PSE module update

LI, Fei
Zhuang, Yan
Huawei Technologies

Ad hoc, Feb. 27th, 2017

Single-pair-pse configuration

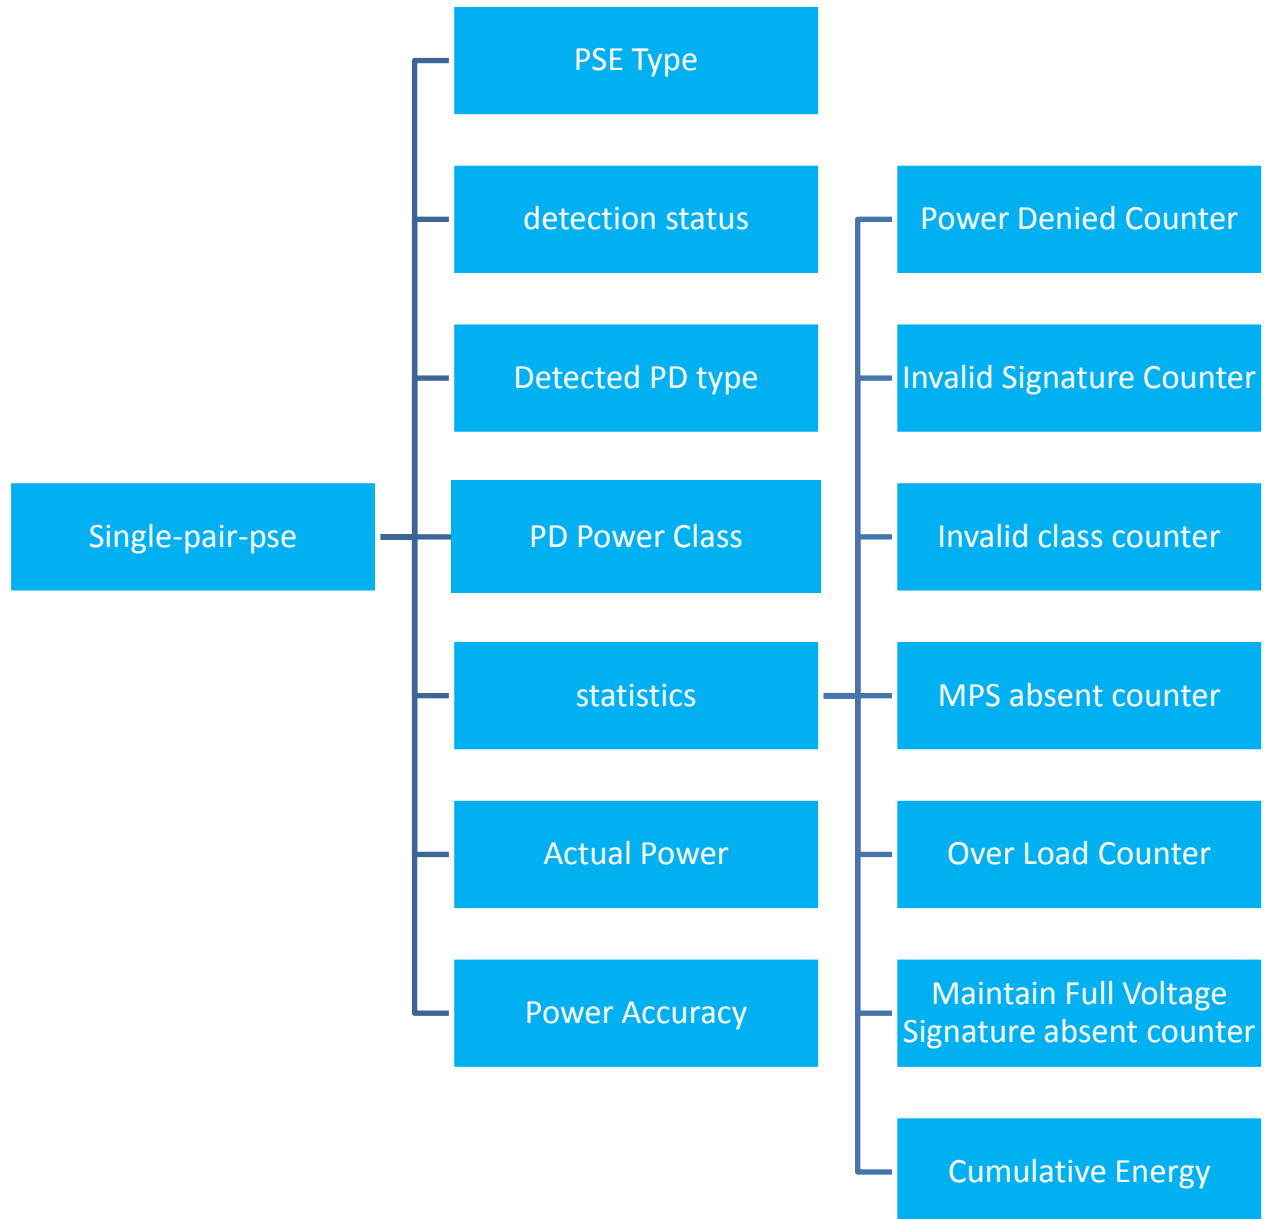
Should we provide more attributes for configuration?
